#### 6.4 TRAINING

8609260308 860917  
PDR ADOCK 05000397  
P PDR

FIGURE 6.2.2-1b  
UNIT ORGANIZATION — OPERATIONS DEPARTMENT

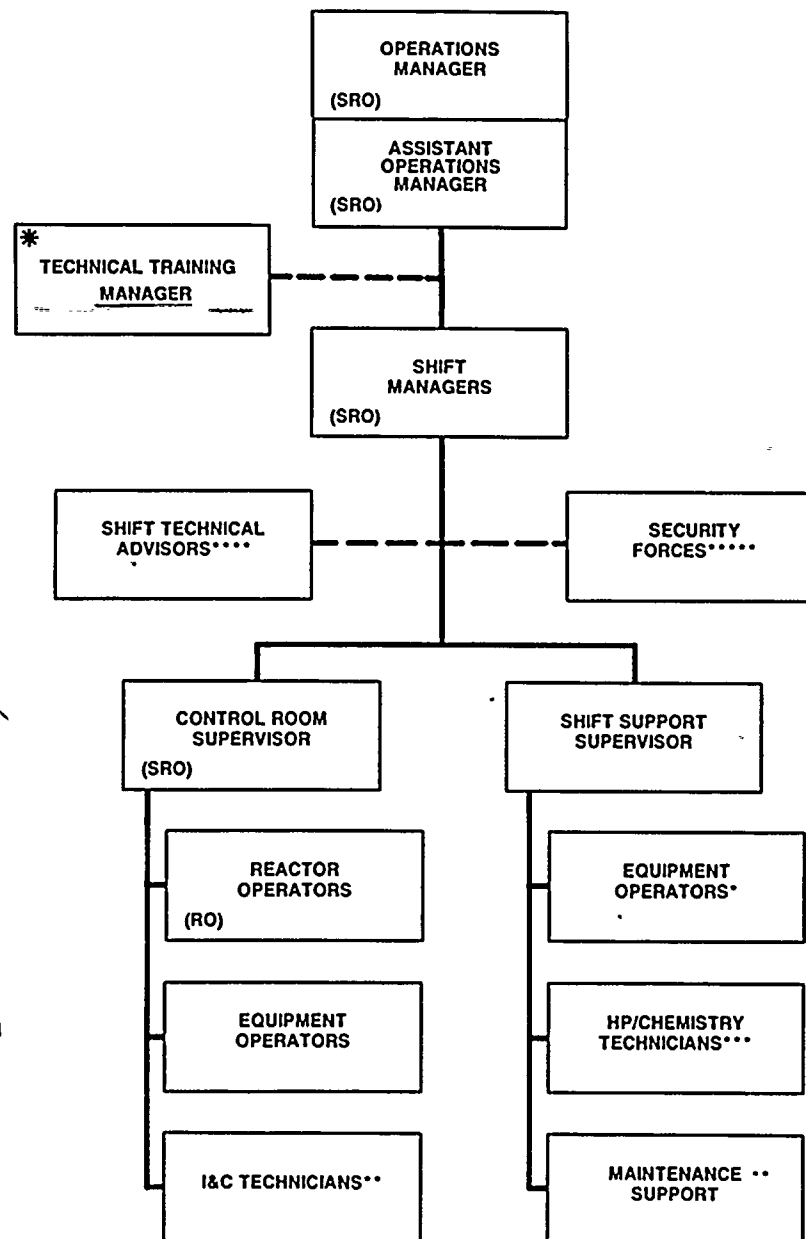
\* MANAGER SHALL ASSIGN FUNCTION TRAINING COORDINATION TO AN INDIVIDUAL WHO WILL COORDINATE DEPARTMENT TRAINING WITH THE TECHNICAL TRAINING MANAGER (PART TIME)
